Aspire 2 - Design Change Legend

Aspire Tucson 2

Concept Design View - N Park Ave Mid-air - Changes

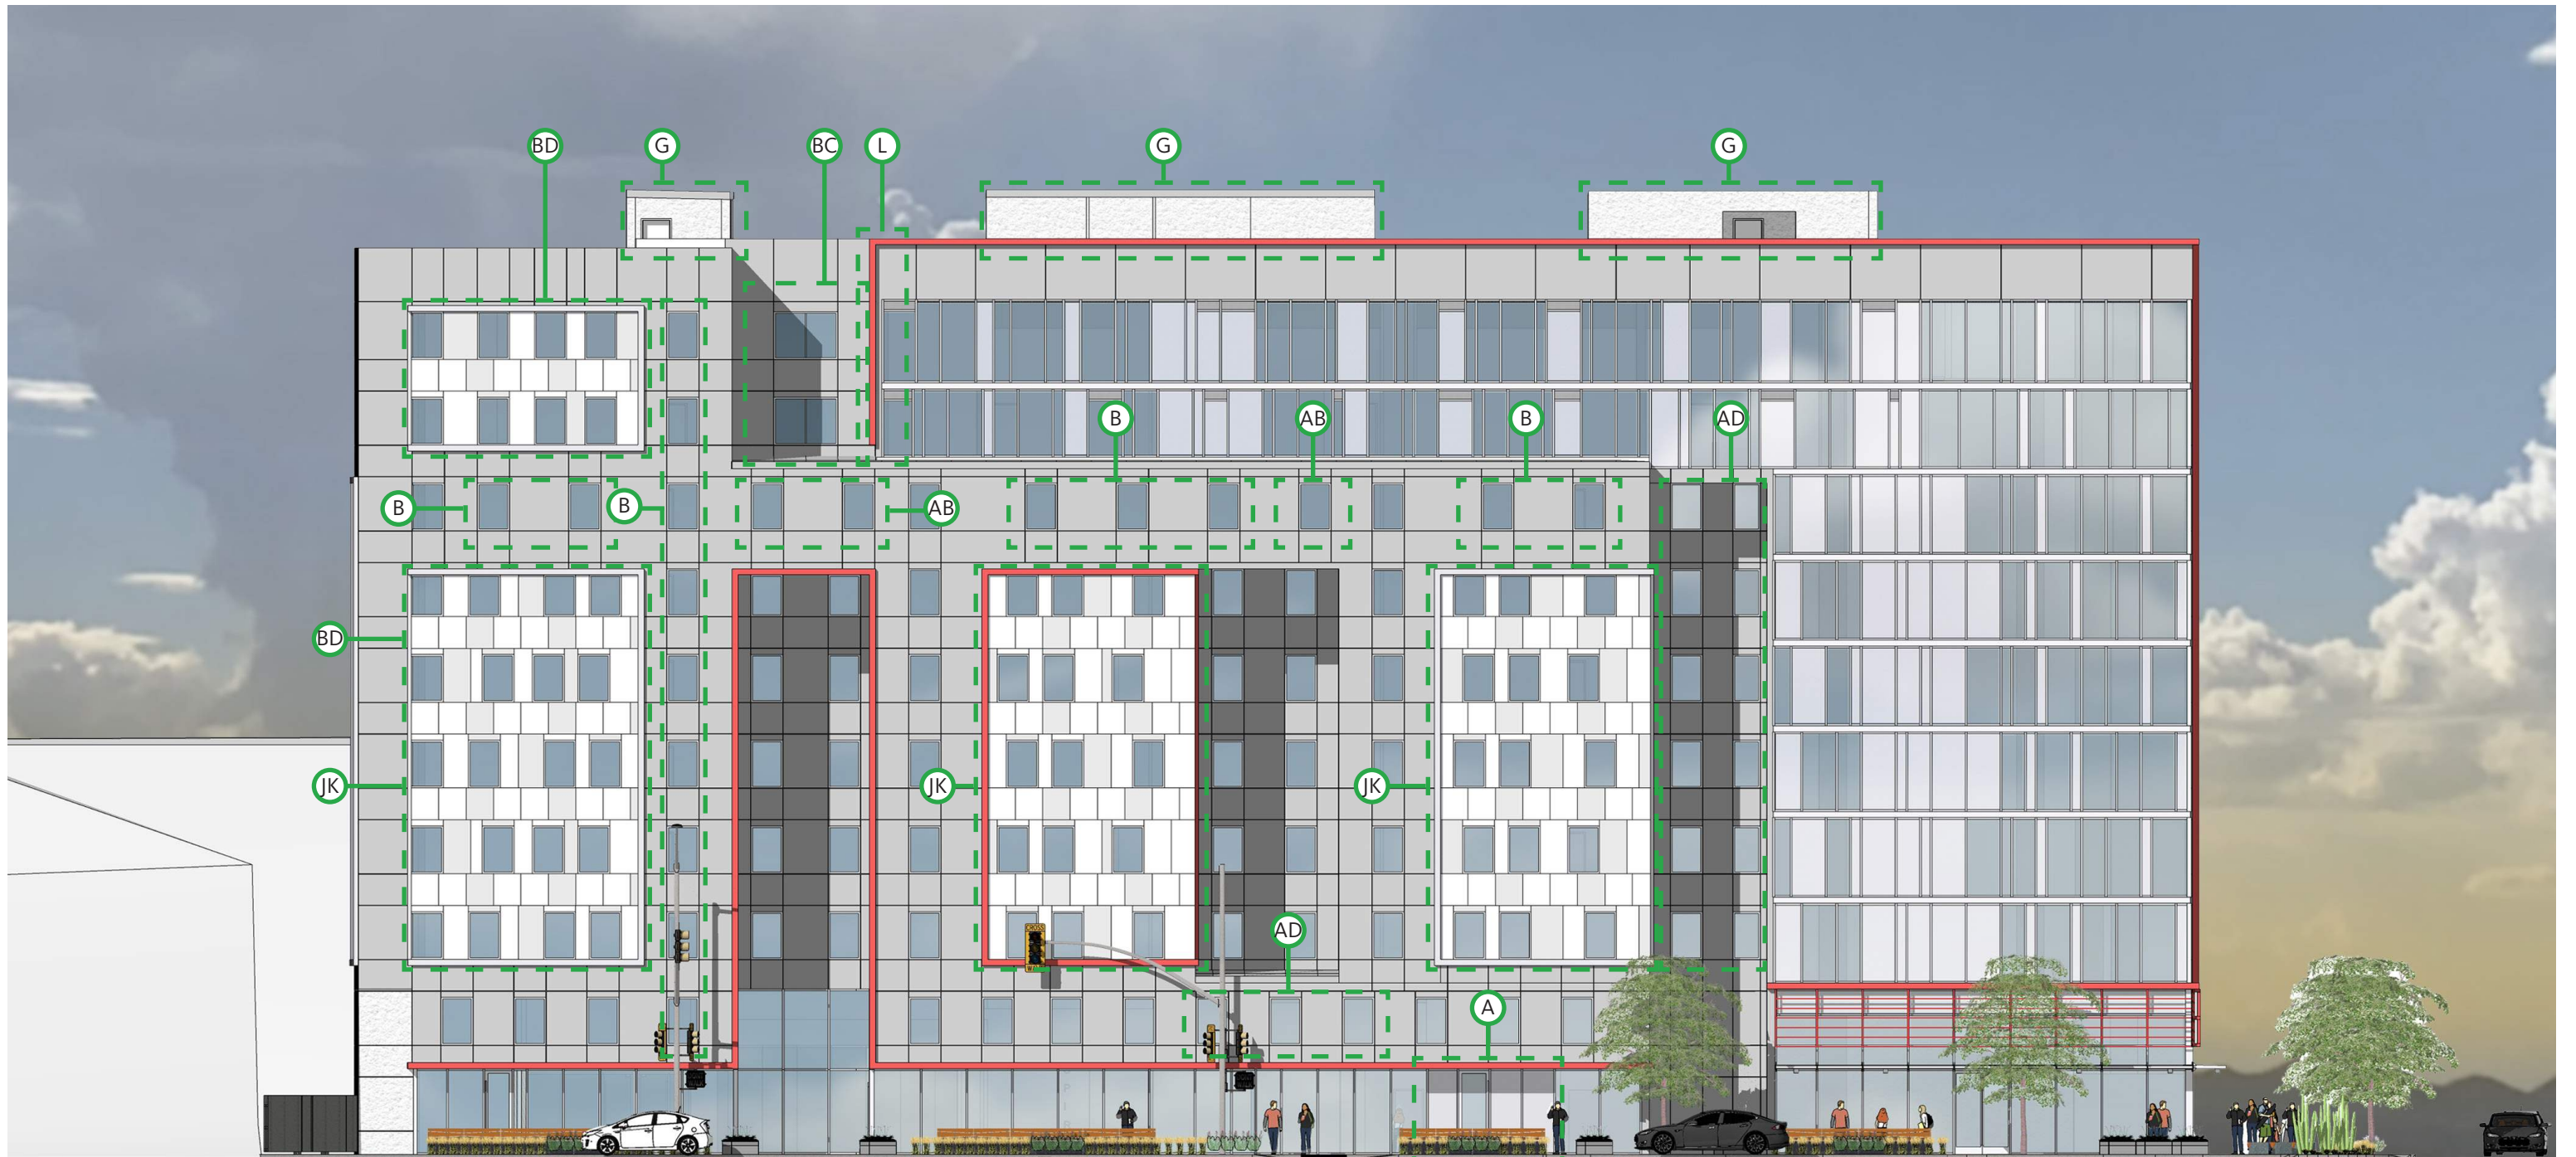
- A. Window Type Changes
- B. Window Location Adjustments
- C. Windows Removed
- D. Windows Added
- E. Red Band Location Adjusted
- F. Added Mechanical Louvers
- G. Roof Core & Mechanical Spaces Updated
- H. Updated Screen & Gate Design
- I. Door Type Changed
- J. Rendering Adjustment to Show Correct Frame Size
- K. Modified Area of Metal Cladding
- L. Wall Moved
- M. Courtyard Parapet Adjusted

Concept Design View - N Park Ave & E 1st St - Changes

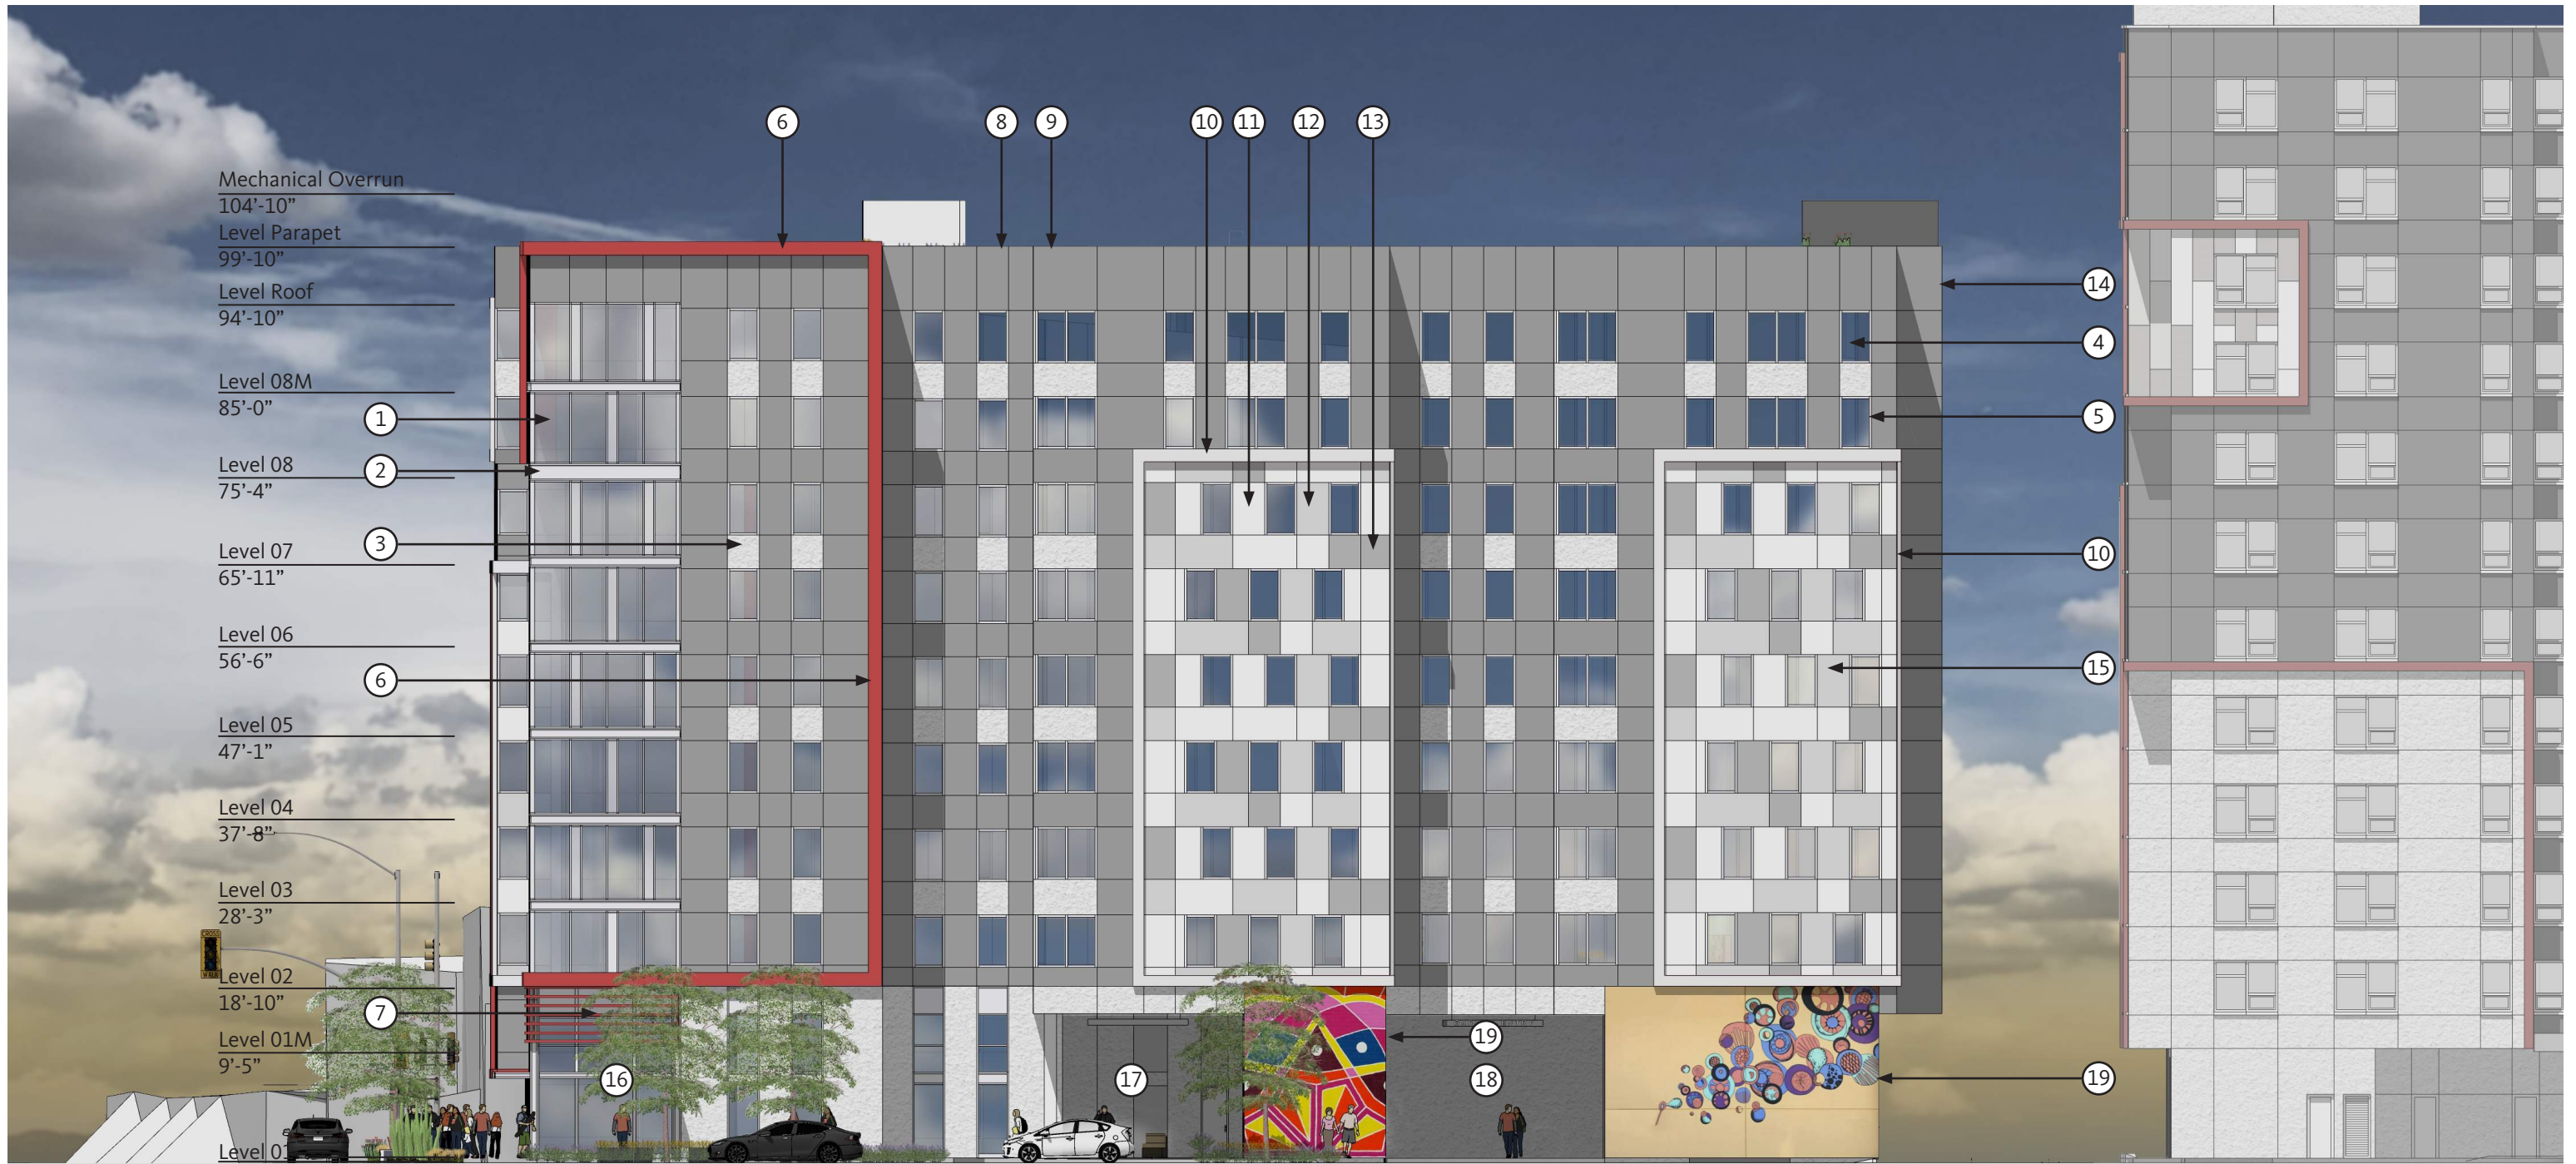
AB D A H
